R09PL

Headlining Rivets

RECALL

MODELS AFFECTED: 2010 D3FE All American School Buses manufactured at Fort Valley, Georgia from January 19, 2009 through May 13, 2009.

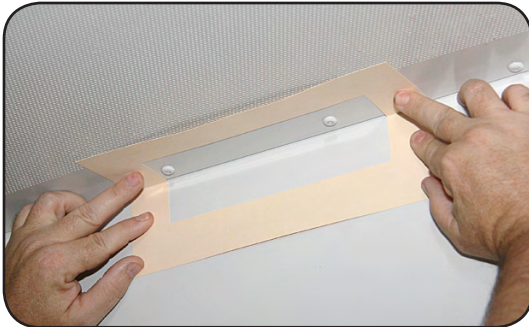
On some units, the rivet spacing may be incorrect in some segments of the rear headlining and rear upper inner panel joint, resulting in noncompliance with FMVSS 221, School Bus Body Joint Strength.

Inspect the rivet spacing at the joint and install additional rivets as required by specification.

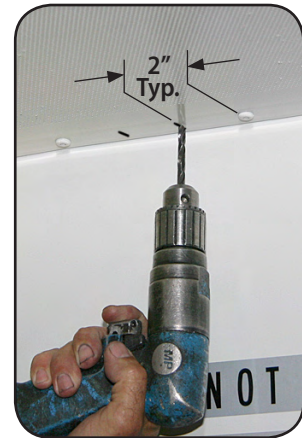
- 1** Park vehicle on level surface, apply parking brake, remove ignition key and chock wheels.
- 2** Inspect rivet spacing at rear headlining and rear upper inner panel joint. Joint must have a minimum of four rivets in an eight inch segment.
 - 2.1 Place the template over the joint and parallel to the edge of the headlining panel, allowing roof rivets to be exposed through the opening in the template as shown.

- 2.2 Move the template from one side of the headlining panel to the opposite side.
- 2.3 If a segment in the rear headlining panel joint contains less than four rivets, additional rivets are required. Mark each area that requires additional rivets. Rivets should be spaced on approx. 2" centers.
- 2.4 If additional rivets are required; add additional rivets between the largest spaces until a minimum of four (4) rivets have been added in the 8 inch segment.

- 3** Using a short 7/32" drill bit, drill a hole through the headlining panel and the rear upper inner panel. Be sure to drill hole on a common center-line with existing rivets.

- 4** Install pre-painted rivet/s in each hole.
